Office of General Services

ADDENDUM NO. 2 TO PROJECT NO. 47676

CONSTRUCTION WORK FUEL TANK MODIFICATION & ENVIRONMENTAL REMEDIATION – WESTERN REGION SERVICE CONTRACT GNARESP CORNING TOWER ALBANY, NY 12242

May 27, 2025

1. NUMBER OF NOZZLES AND PIPE SIZES ARE DIAGRAM ONLY. ACTUAL PIPE SIZE AND ROUTING TO BE VENDER CERTIFIED AND DESIGNED FOR HAZARD AREA.
2. SYSTEM TO BE UL1254 AND AS PER NFPA-17.

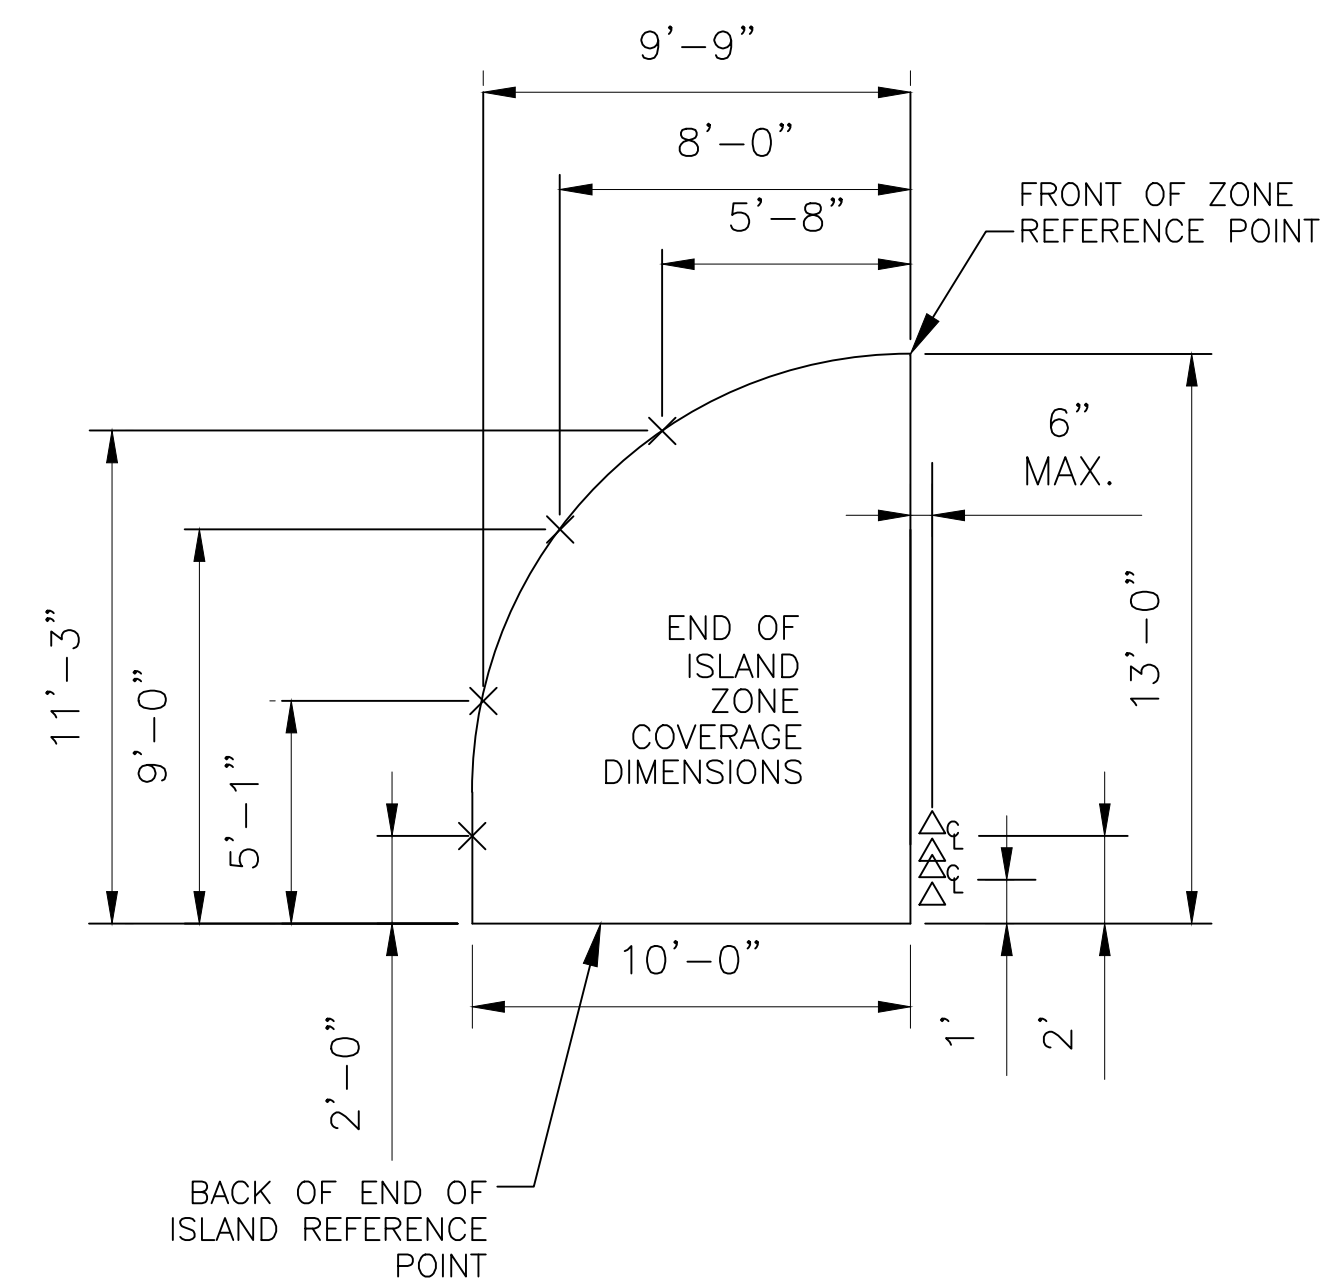
2. Revised Drawings:
 - a. Drawing Nos. C-23, C-24, and C-25, noted “ADDENDUM NO. 2 5/22/2025” accompany this Addendum and supersede the same numbered originally issued drawings.
